**City of Ryde
Local Planning Panel Report**

DA Number	LDA2022/0098
Site Address & Ward	31 Campbell Street, Eastwood West Ward
Zoning	R2 Low Density Residential
Proposal	Alterations and additions to existing dwelling house, construction of an additional two storey dwelling house to create a dual occupancy (detached), Torrens title subdivision & removal of trees
Property Owner	Shaohui Zhao
Applicant	Archian Pty Ltd – Colin Jiang
Report Author	Niroshini Stephen – Senior Town Planner
Lodgement Date	28 March 2022
No. of Submissions	Four (4) submissions received
Cost of Works	\$973,500.00
Reason for Referral to LPP	<p>Sensitive Development - Schedule 1, Part 4 of Local Planning Panels Direction.</p> <p>Demolition of part of a heritage item and removal of trees</p> <p>Departure from Development Standard - Schedule 1, Part 3 of Local Planning Panels Direction.</p> <p>Subdivision creates lot sizes resulting in greater than 10% variation from the development standard for minimum subdivision lot size imposed by Clause 4.1 of RLEP 2014. No Clause 4.6 submitted.</p>

Recommendation	Refusal
Attachments	Attachment 1: Compliance Table Attachment 2: Plans submitted with LDA

Figure 23 – Section plan of existing dwelling showing non compliant floor to ceiling height of 2.20 metres

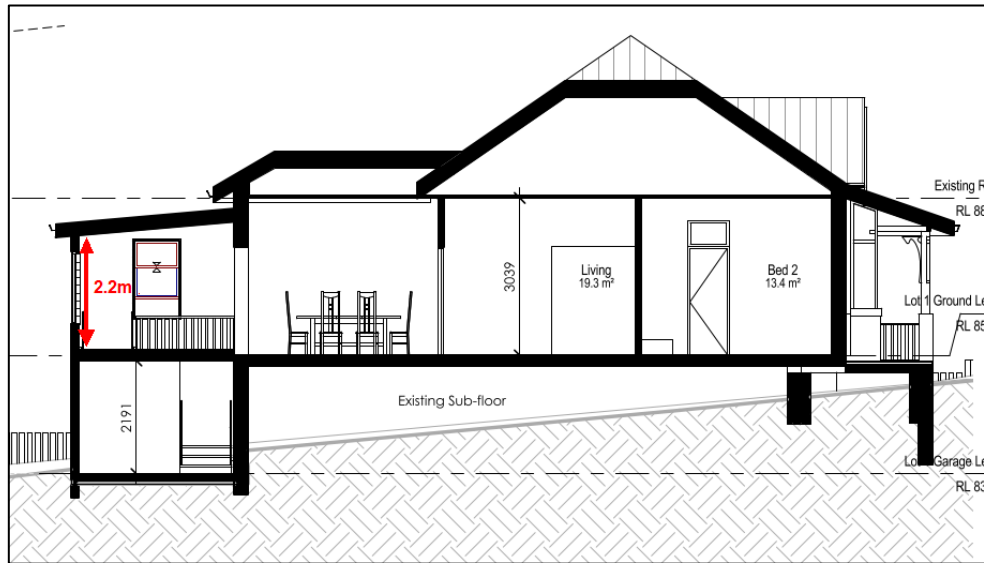
Control 2.8.2(a) requires the minimum ceiling height for habitable rooms is to be 2.4m. The extension of the living area to the rear of the existing dwelling has a floor to ceiling

height of 2.2 metres and does not comply with Control 2.8.2(a). This forms reason for refusal of the application.

Figure 24 – Rear setback measured from rear northern elevation of new dwelling to boundary

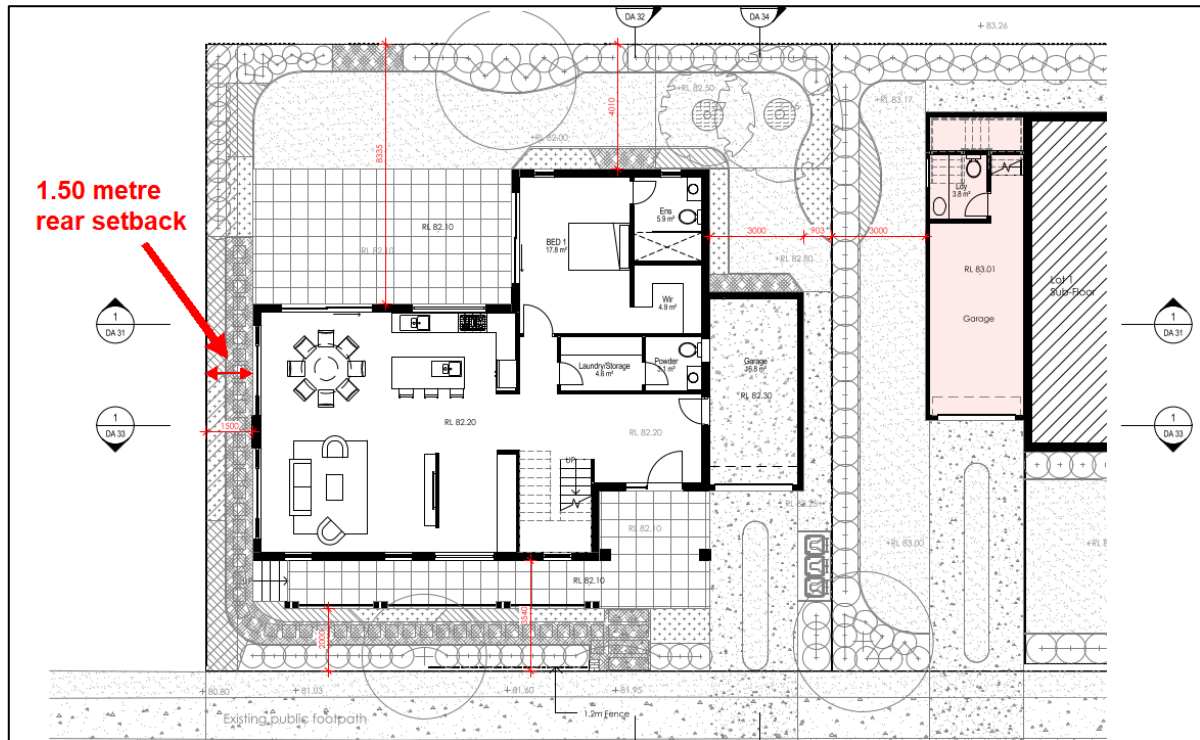
- The new dwelling has a reduced setback to the rear boundary to increase separation from the existing heritage item;
- A suitable area for private outdoor recreation is provided;

- The site is a corner allotment and does not enable a reasonable building footprint if a compliant rear setback were provided;
- The development provides 44.2% of deep soil area and complies with Control 2.6.1(a) which requires sites to have a deep soil area that is at least 35% of the area of the allotment; and
- There is sufficient area for vegetation and mature trees

Figure 25 – Elevated alfresco highlighted on northern elevation

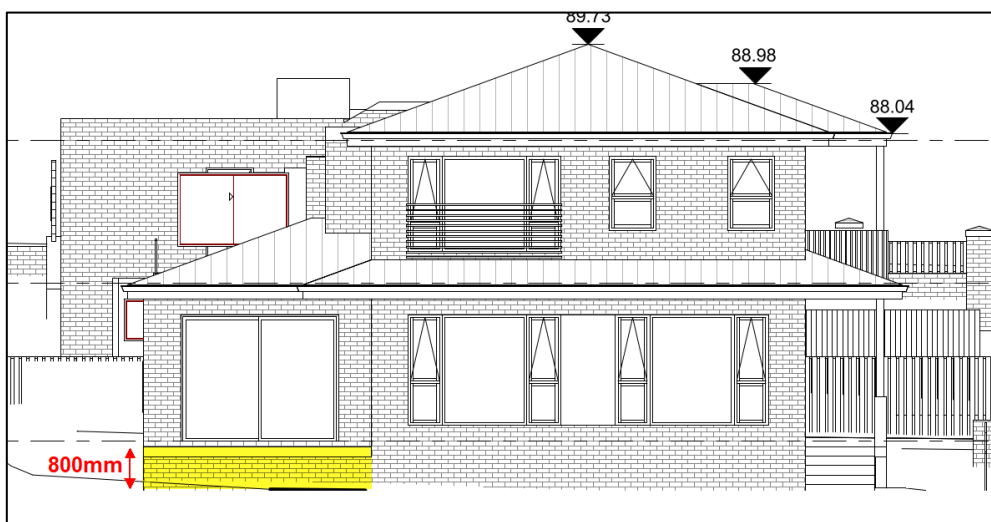
Control 2.14.2(b) requires terraces, balconies and outdoor living areas to be orientated to either the front or the rear of allotments, and not to the side boundaries. Control 2.14.2(c) requires terraces and balconies are not to overlook neighbour’s living areas and private open space.

The alfresco associated with the new dwelling orientates to the side boundary and rear boundary. The eastern elevation of the alfresco is elevated 600mm above the existing ground level and has a reduced setback of 4 metres from the side boundary. The northern elevation of the alfresco is elevated 800mm above the existing ground level and has a reduced setback of 1.5 metres from the rear boundary. The alfresco results in overlooking into the private open space of 29 Campbell Street and 56 Rutledge Street. This forms reason for refusal of the application.

Figure 27 – Difference in levels of Lot 1 and Lot 2 circled in green on landscape plan

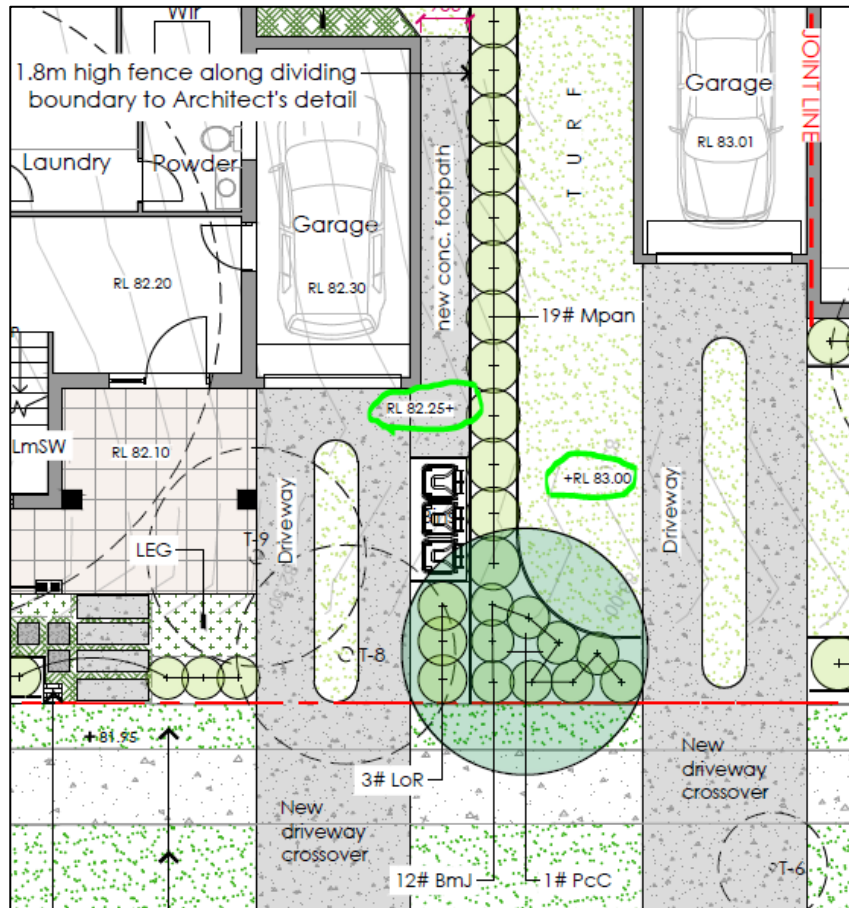
- *It is unclear what elevations or cross fall that both driveways are proposed to be. In this regard, the applicant is to provide cross section at Section A (marked below) showing the existing and proposed elevations and gradients.*

Development engineer’s response: No cross-section profile was provided to address this RFI item. There is 700mm difference between the FFL of garages

and about 750mm difference between ground levels just outside both garages (highlighted in green in the below plan). It appears a retaining structure will be required to support the ground levels difference between two lots. A condition of consent will apply – prior to the issue of CC, appropriate retaining structures design shall be provided to support ground levels difference between the two lots prior to the issue of CC.

Figure 28 – Location of existing trees

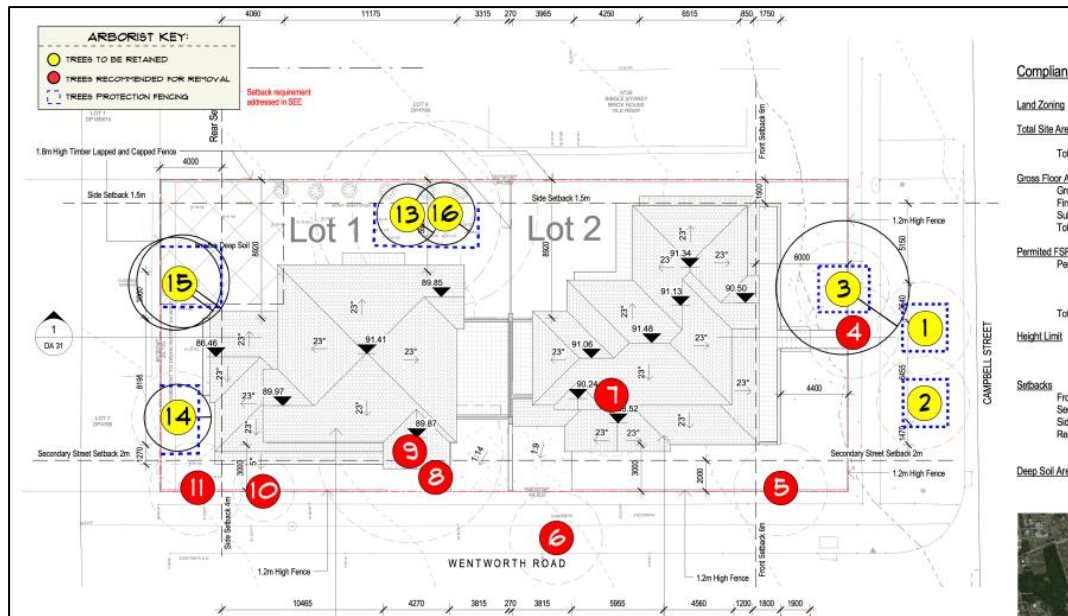
Tree 4 is required to be removed for the front fence. Tree 5 and Tree 6 are exempt as the trees are less than 5 metres high. Tree 7 is an exempt tree within 4 metres of the existing dwelling. Tree 8, Tree 9, Tree 11 and Tree 12 are required to be removed as the proposal results in major encroachment. Tree 10 is a poor quality tree and removal is supported. Tree 15 is an exempt species and removal is supported.

The proposal seeks to retain Tree 14 which is a *Tristaniopsis laurina* (Water Gum). The proposal will result in major encroachment onto this tree and the removal of the tree is supported. The proposal results in the removal of eleven (11) trees.
